XC1001-A new firmware

**92, Fire Protection**  
Product information  
No. 92E008-I

## New Firmware v2.7 for XC1001-A Technical Manual for XC1001-A updated

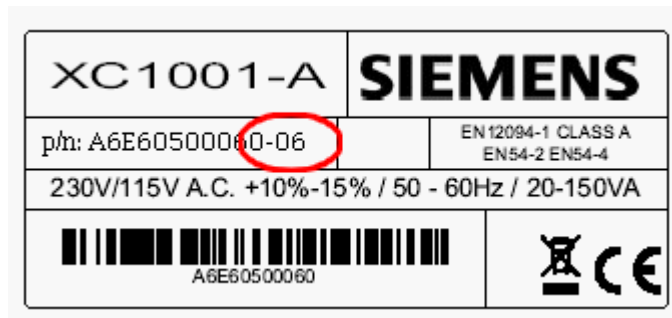
- An update of existing installation is **not required**
- The new SW 2.7 will be implemented on stock approximately from mid of June
- The technical manual will be available on STEPS from beginning of June
- How to identify new SW version :
  - on the main board :

- on the product label :
